March 27, 2013

Barbara Parsons, Chair  
Town of Wawayanda Planning Board  
80 Ridgebury Hill Rd.  
Slate Hill, NY 10973

**RE: Risk of Structural Damage to the Proposed CPV Valley Energy Project Power Plant from Earthquakes**

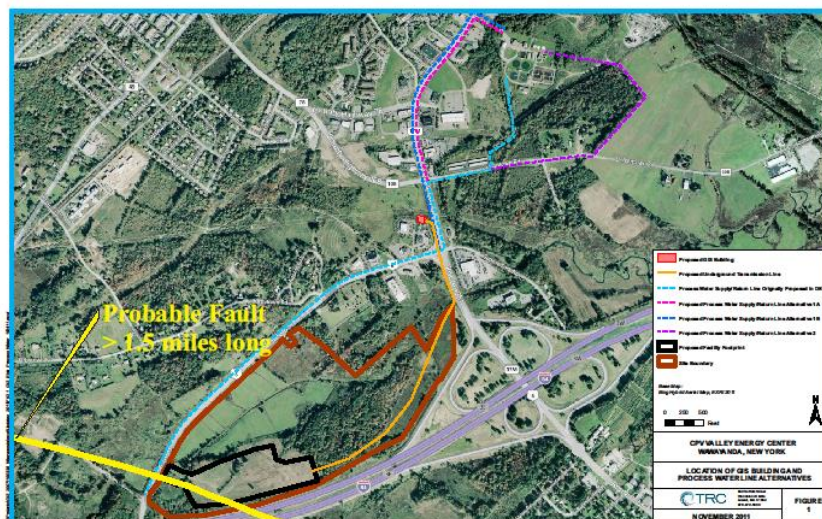
Reference to Figure 1 below shows a small portion of what has been referred to as a bedrock fracture trace. The fracture information upon which this is based is data offered to the public from the Orange County GIS Department gisportal (see <http://www.co.orange.ny.us/content/124/1344/1410/default.aspx>). I have superimposed the bedrock fracture on a November 2011 TRC map. The fracture is illustrated as a yellow line that extends far beyond the area depicted for a distance in excess of 1.5 miles.

As a geologist familiar with the region, I have extensive experience mapping, measuring, and plotting fractures that occur in sedimentary bedrock. My field experience includes measuring fractures and faults in quarries, mines, caves, and in numerous bedrock outcrops. There are different kinds of fractures. The most common are referred to as joints. These are found everywhere in New York State and far beyond. They are mappable in the field where bedrock exposures are present. Faults are another type of fracture. Many are miles in length and can be identified and mapped using high resolution photoimagery, especially through the use of stereo areal photography. High resolution imagery was probably used to identify the fracture plotted on Figure 1 above that runs directly through the proposed power plant site.

Most joints in NYS are high angle and do not necessarily infer the presence of either active or inactive faults (i.e., seismic activity). The bedrock fracture illustrated on Figure 1 and beyond is greater than 1.5 miles in length. Based on familiarity with joints and joint sets in NYS, I am aware that few individual joints exceed a length of about 2,000 feet. Thus, the bedrock fracture illustrated in Figure 1 is almost certainly a major fault. Faults represent zones of preferential weakness that may become activated during earthquake events. Siting a power plant over or close to a fault or fault zone would not be prudent and should be avoided. Seismic events may cause disruption in plant functioning and release of fuels and other chemicals used and stored on site. An alternate site should be selected for the proposed CPV Valley Energy Project power plant.

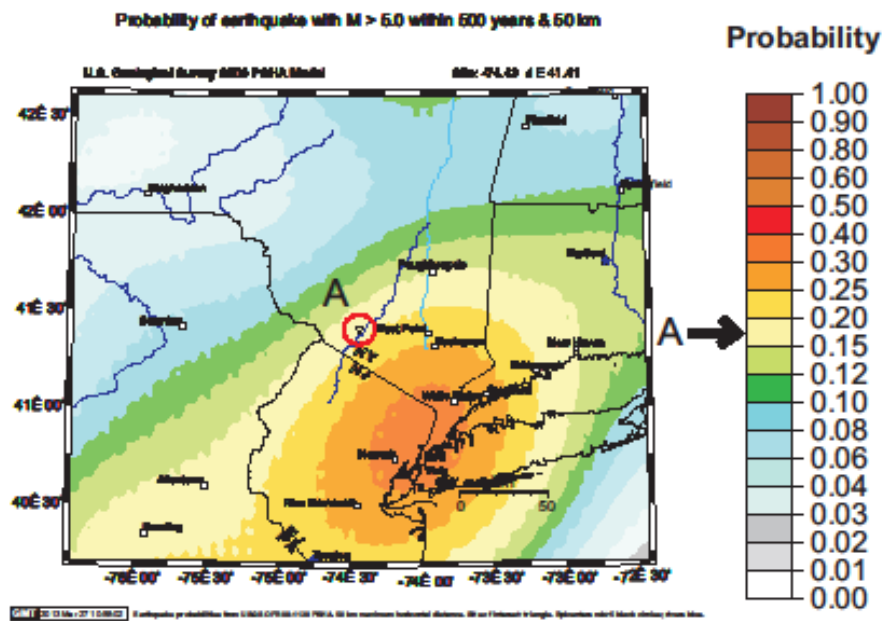
An analysis of earthquake probability at the Wawayanda site was conducted. The probability of earthquakes with magnitudes of greater than 5.0 was examined. *HydroQuest* assessed the probability of earthquakes in the greater New Hampton area using the proposed power plant site as a focal point. Modeling of earthquake probability was conducted using the USGS 2009 Earthquake Probability Mapping model and related data available from the USGS Geologic Hazards Science Center. A series of model runs were conducted to assess and graphically display earthquake probabilities that were computed from the source model of the 2008 USGS-National Seismic Hazard Mapping Project (NSHMP) update for New Hampton, NY (41.41° N, -74.43° W). Figures 2, 3, and 4 show the probability of earthquakes with magnitudes of > 5.0 within a radius of 50 km for 200, 500, and 5,000-year events. The USGS web-based model runs determined earthquake probability percent for these events to be 6 to 8 percent, 15 to 20 percent, and 80 to 90 percent, respectively. It is important to recognize that these probabilities are based only on the historic earthquake record to date. As time and more earthquakes occur it is likely that the probabilities will increase.

The very real and high earthquake probabilities presented in Figures 2, 3, and 4 above stem from USGS web-based model runs conducted by *HydroQuest*. The probabilities for each of these events are based on known, recorded, earthquakes. Clearly, earthquake probability and the risk to the structural integrity of the proposed CPV Valley Energy Project power plant and any chemical containment structures are both real and high. Geologically, and from a risk standpoint, it would not be prudent to locate a power plant over a known fault or fault zone. *HydroQuest* recommends that an alternate site be selected. Approval for the proposed power plant should be denied.
